**SECTION 96(2) APPLICATION**  
**MODIFICATION OF CONSENT No.267-11-99**  
**ROBERTS ROAD**  
**MARROTA**

17 July, 2000

This report has been prepared in support of an application pursuant to Section 96 (2) of the Environmental Planning and Assessment Act, 1979 to amend the abovementioned consent.

FIGURE 1 LOCATION OF PROPOSED BERMS

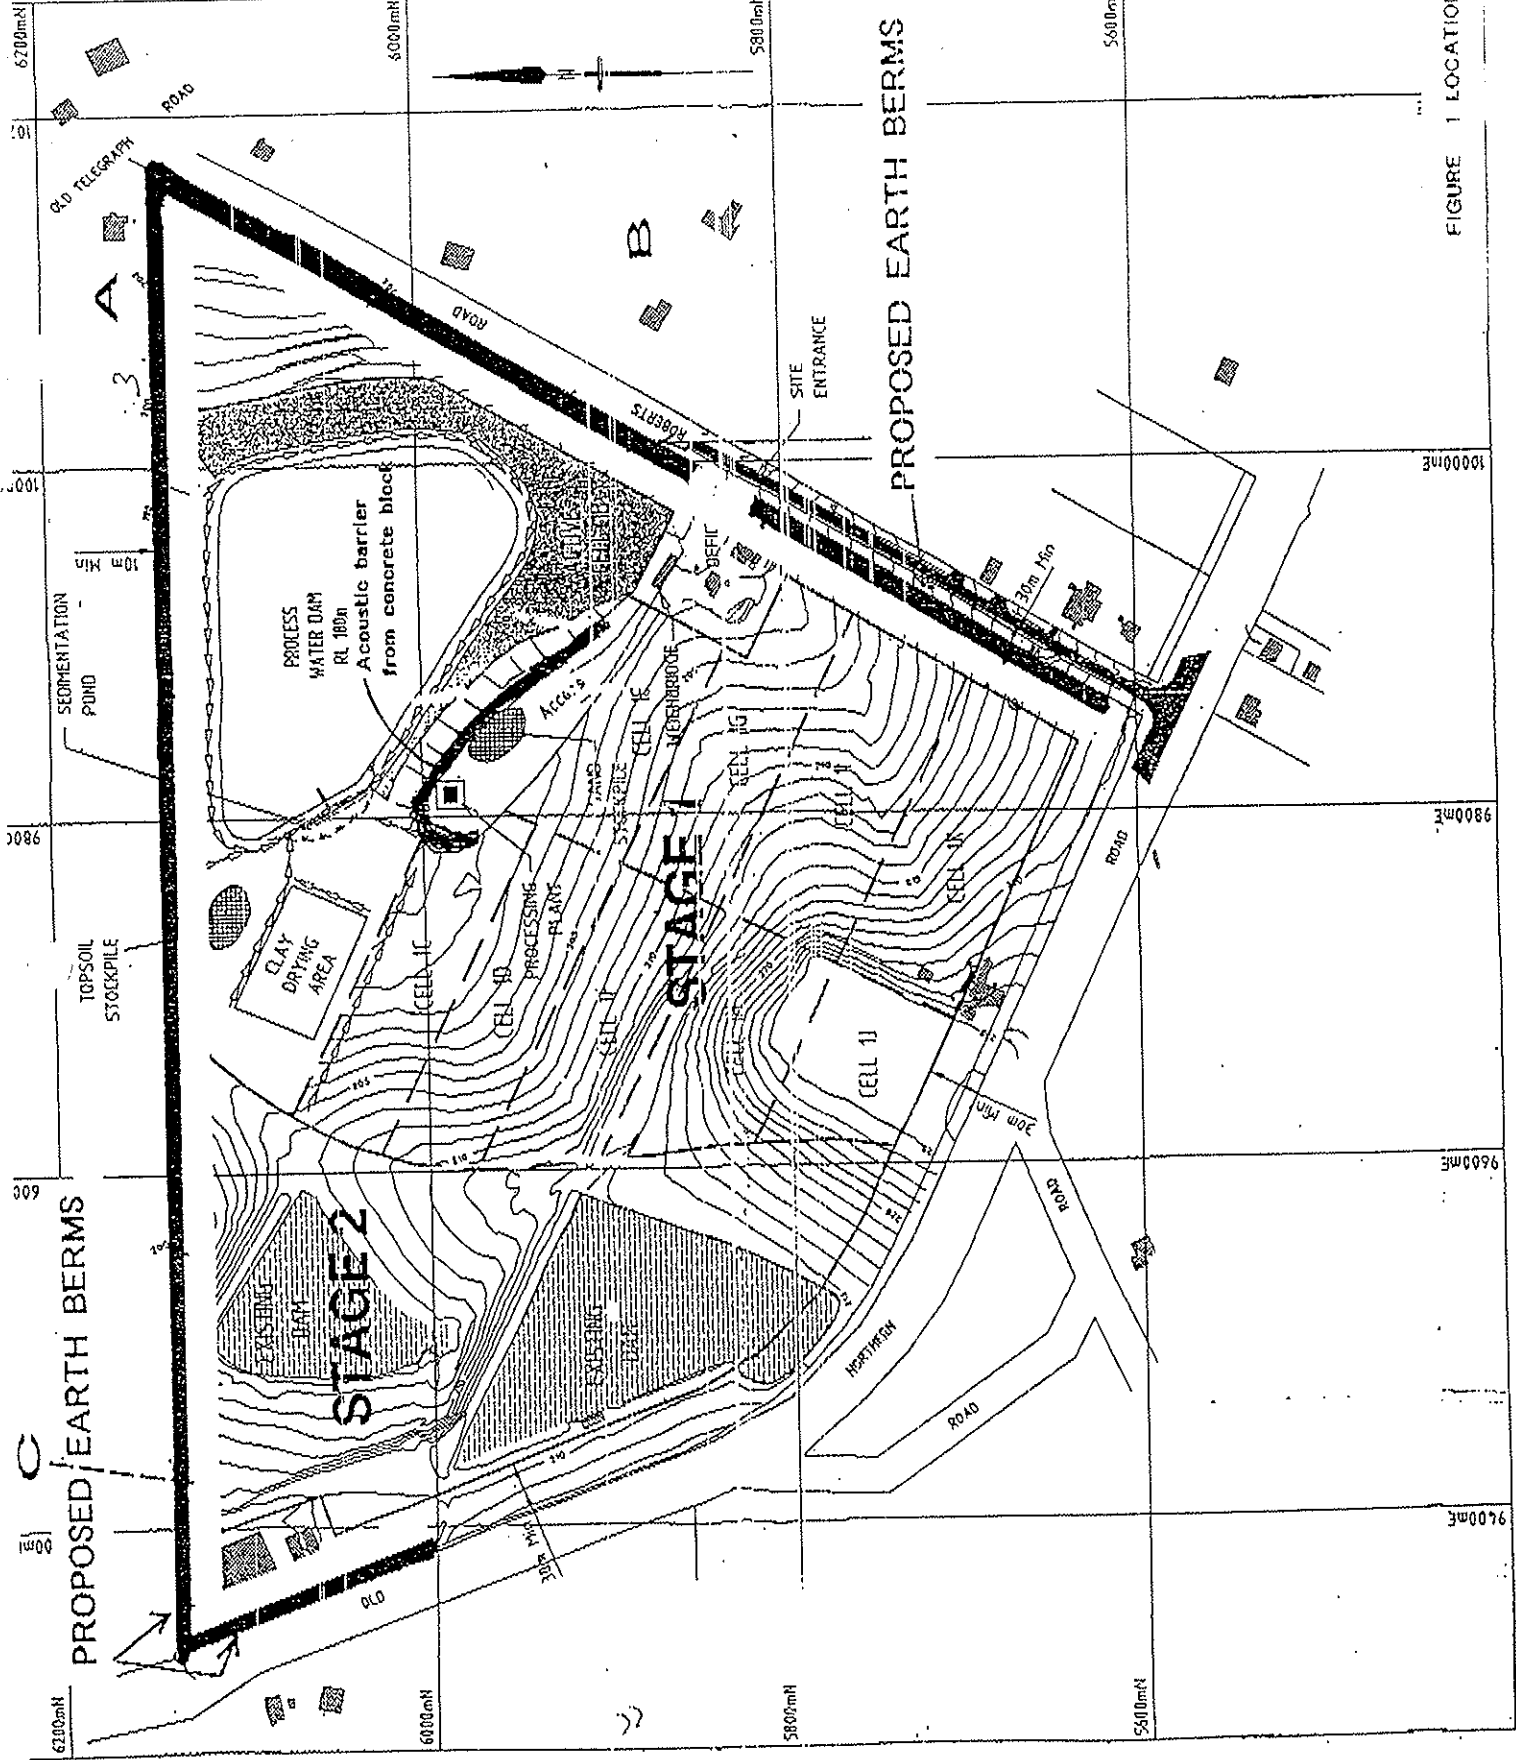
Figure 1 shows the location of these berms.

Additional noise control is required by use of a combination of concrete blocks and some sand material (if necessary) to effect acoustic barriers so that the mobile equipment will have a 5 -- 8 dB(A) noise reduction. Figure 1 shows the location of the acoustic barrier.

**INITIAL EARTH BUNDING & BOUNDARY PLANTING PLAN**

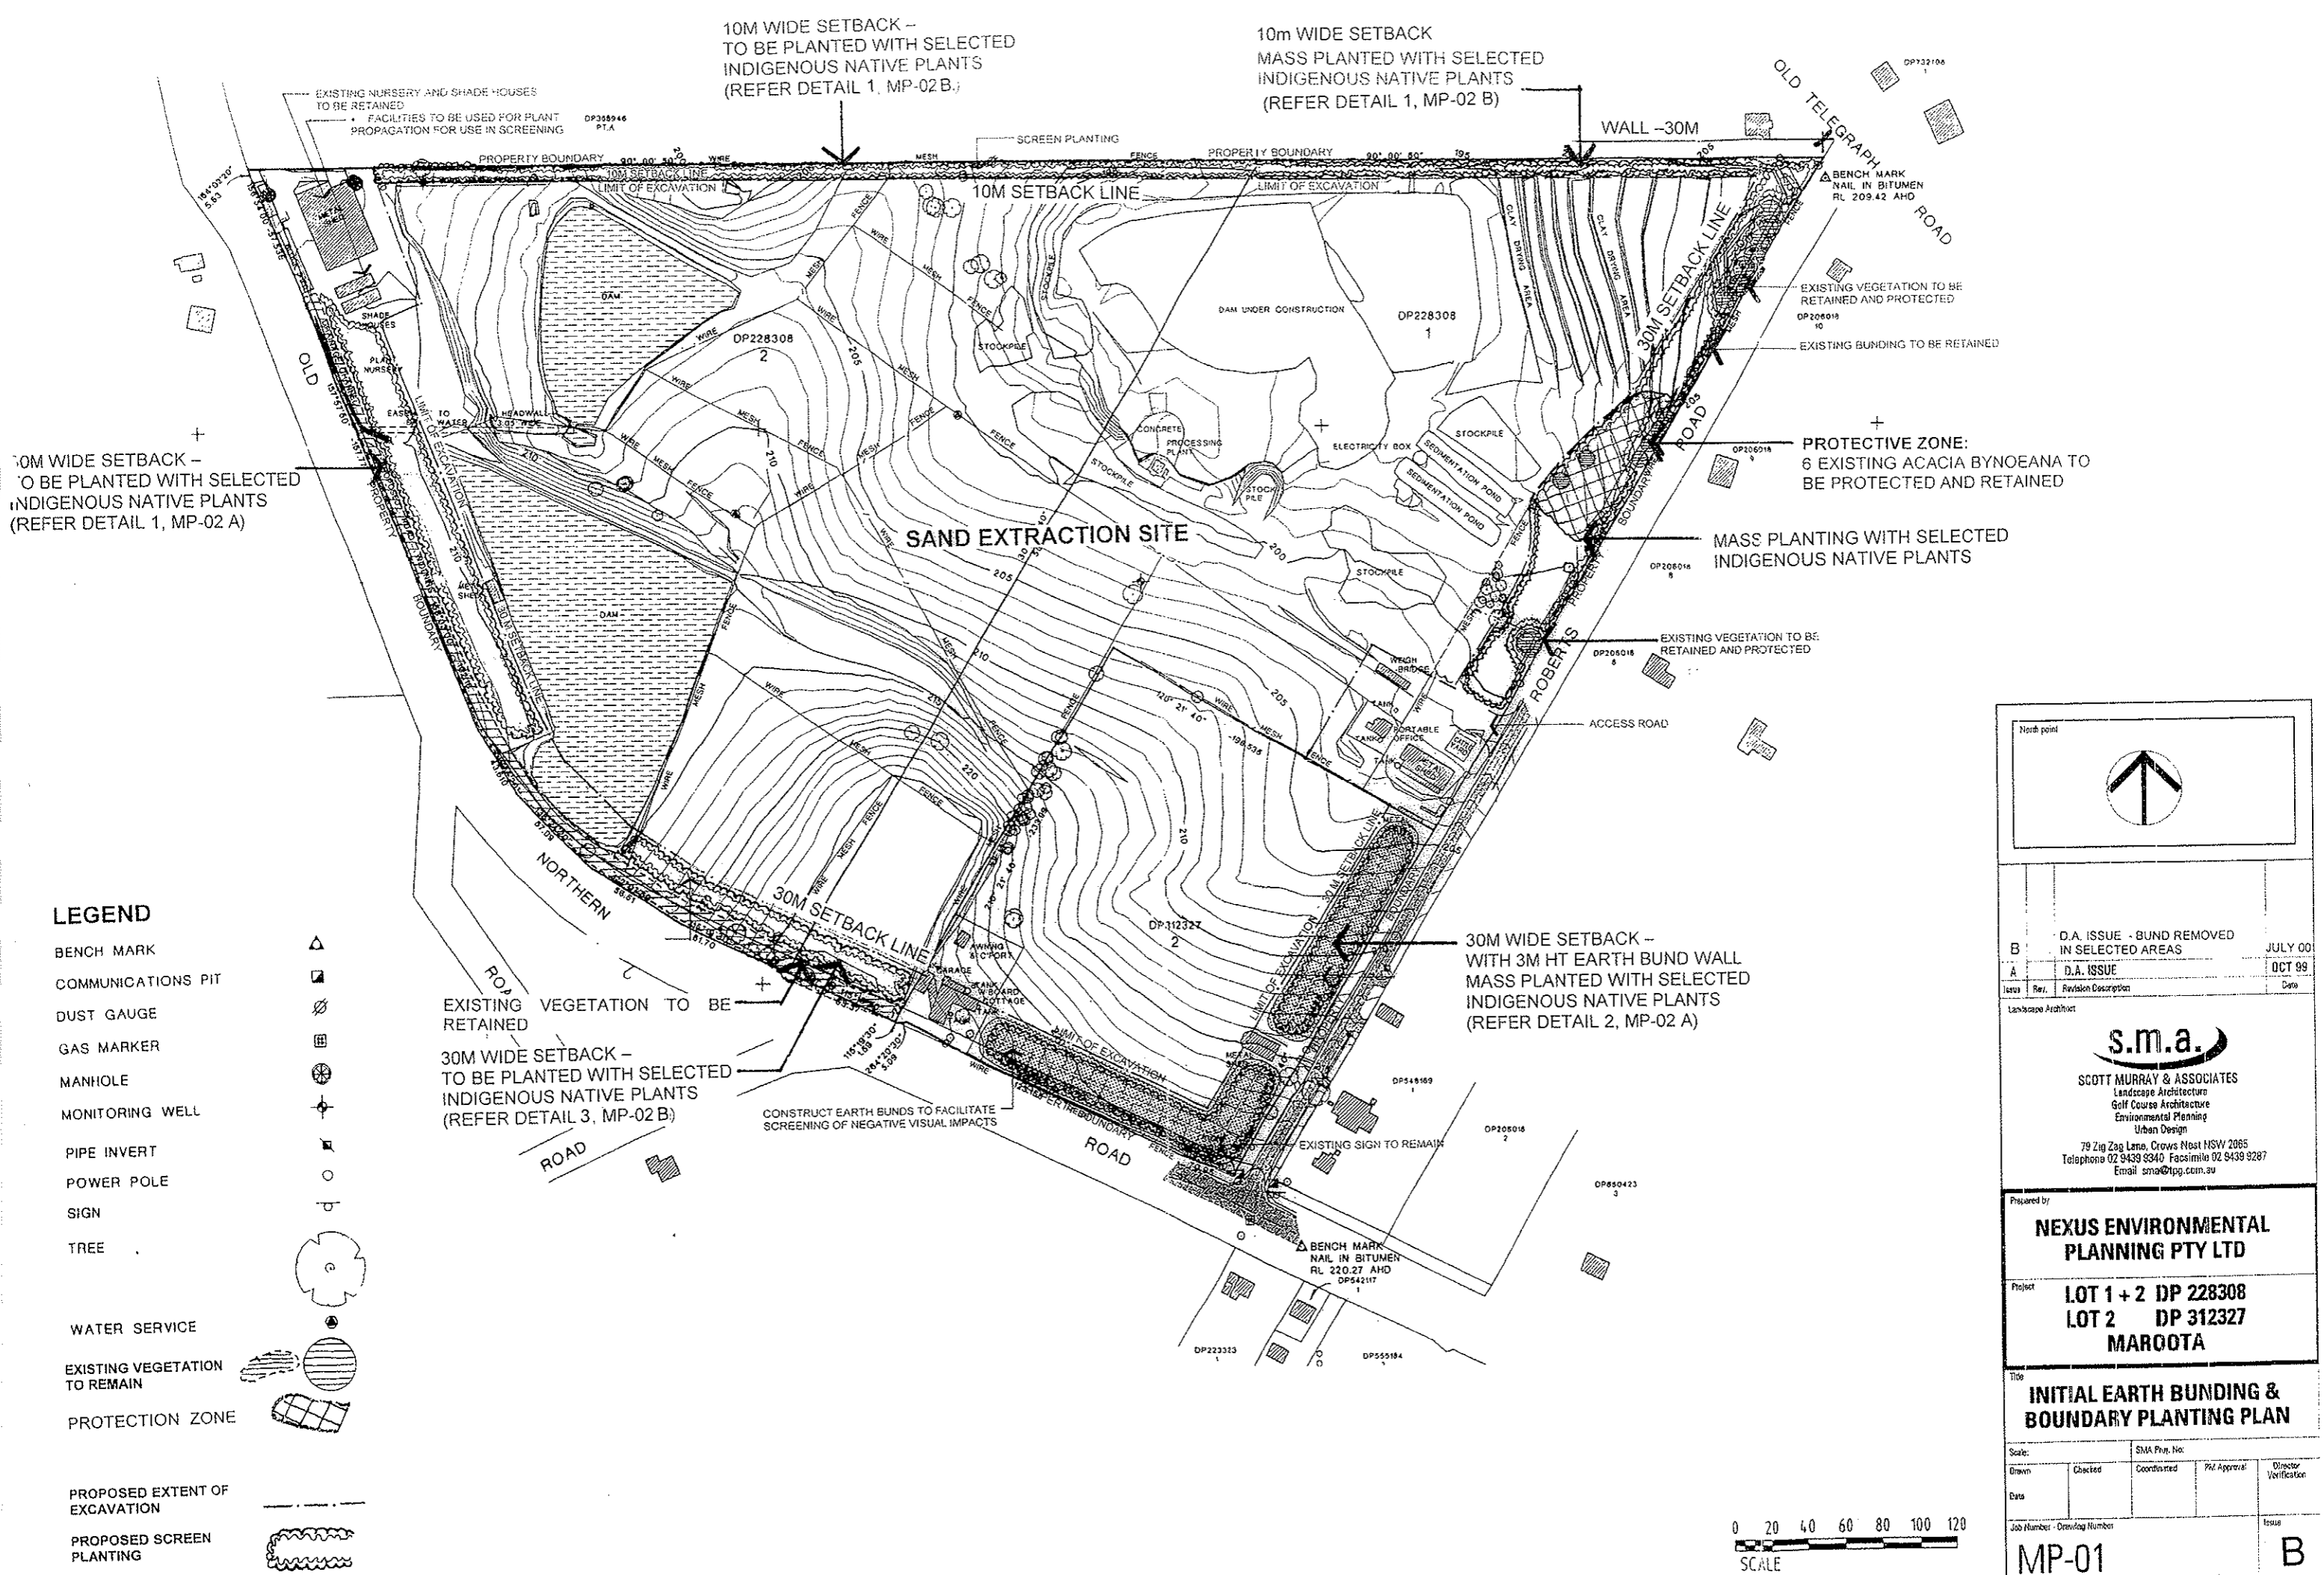
As a consequence, it is therefore recommended – from a purely visual impact standpoint - that initial earth bunding still be implemented at the intersection of Old Northern and Roberts Road to prevent views into the site of the early stage 1 works. Plan **MP-01B** shows this revised bunding strategy. As in the previous scheme, this bunding would achieve heights of up to approximately 3 metres within the 30 metre setback, using a maximum 1:4 road-facing slope.

All other earth bunding previously proposed within boundary perimeter setbacks is now to be deleted as it is no longer required from either a visual impact or noise perspective. Again, plan **MP-01B** shows the current proposal.

Title  
**YEAR 3 PROGRESSIVE REHABILITATION PLAN & SECTION - STAGE 1 WORKS**

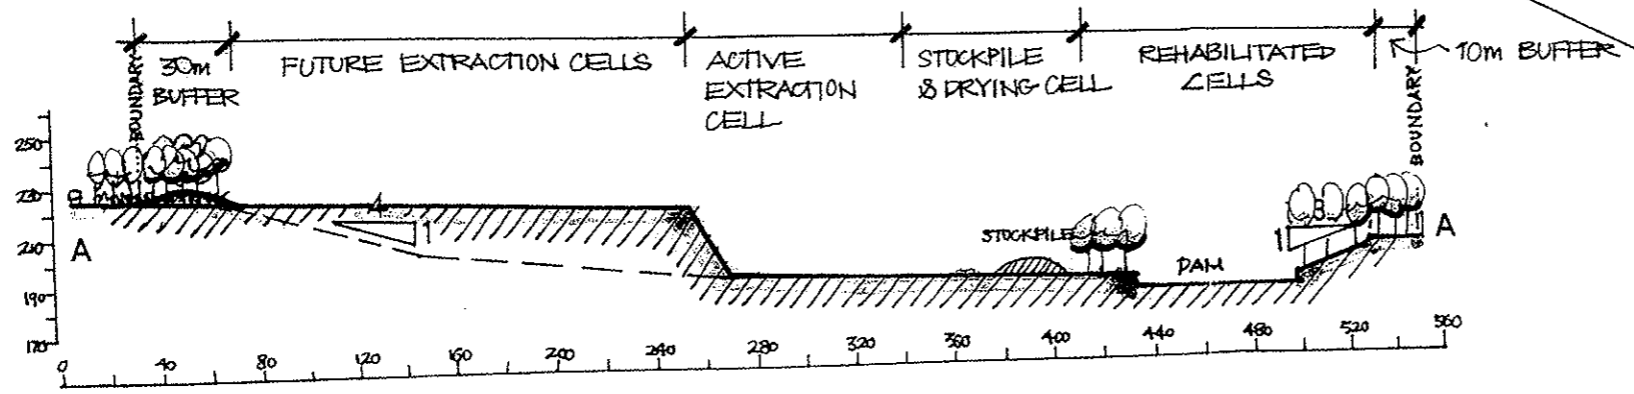
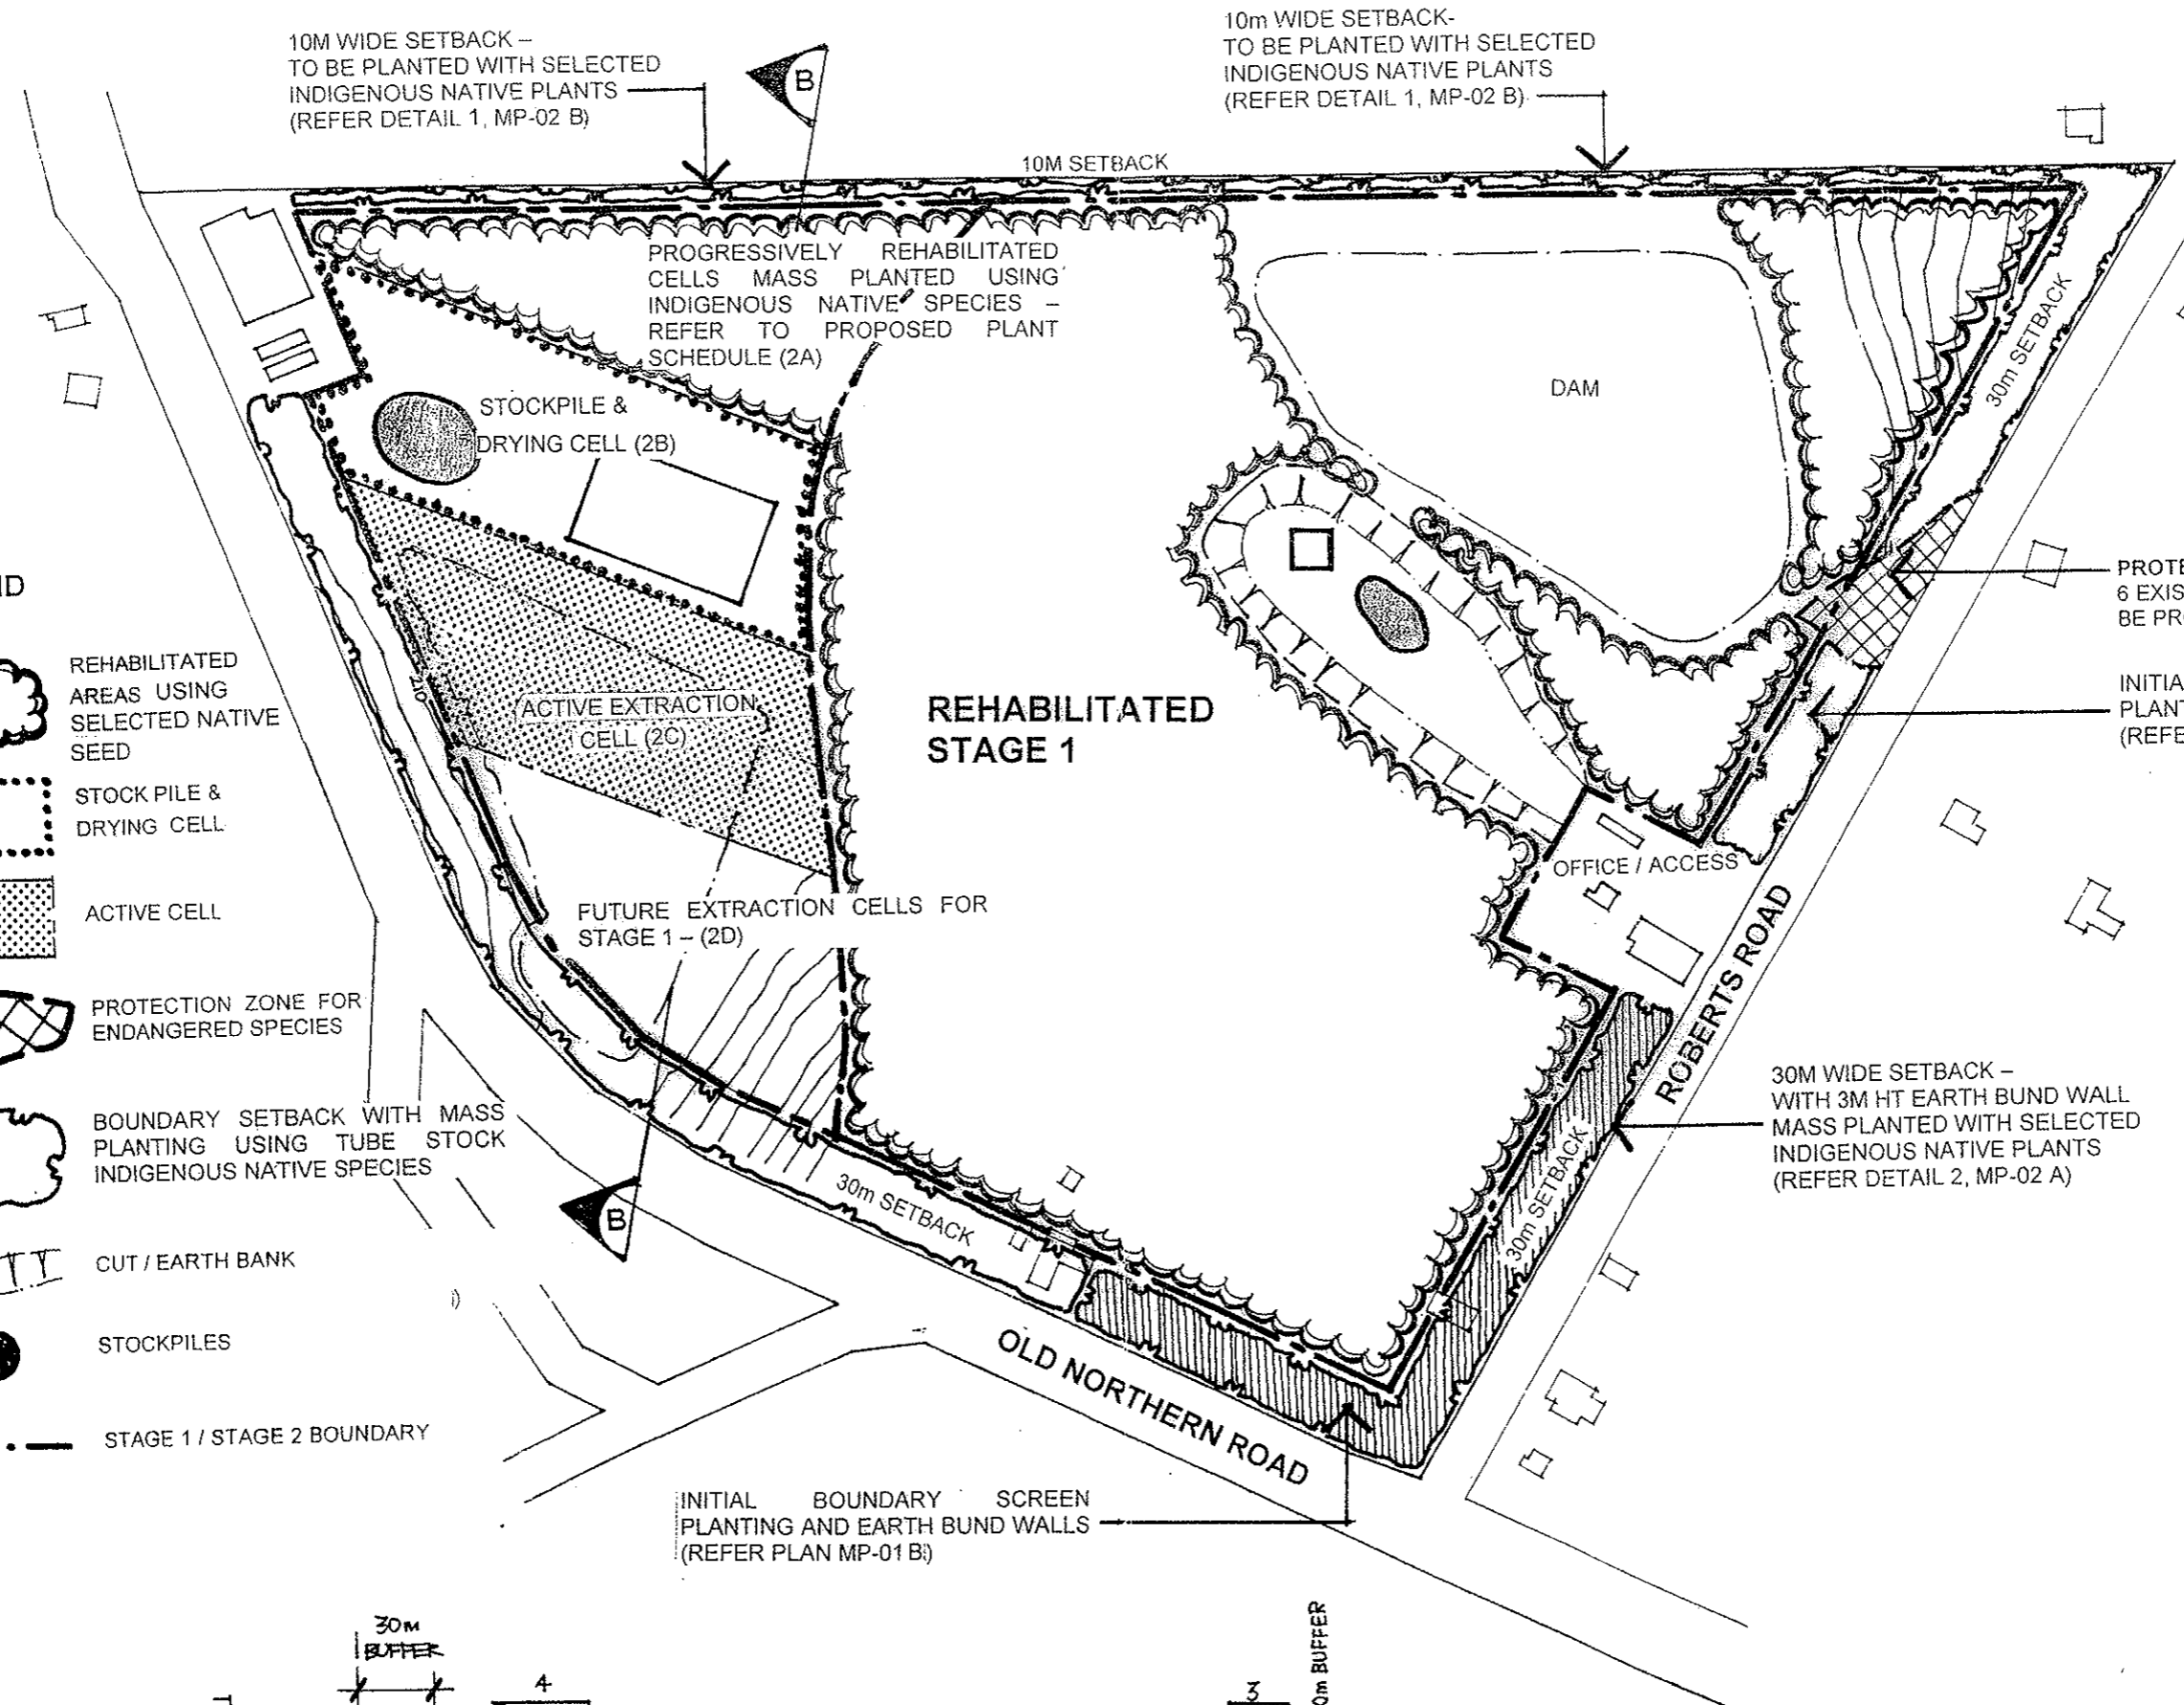
B	D.A. ISSUE - BUND REMOVED IN SELECTED AREAS	JULY 00
A	D.A. ISSUE	OCT 99
Issue	Rev.	Date
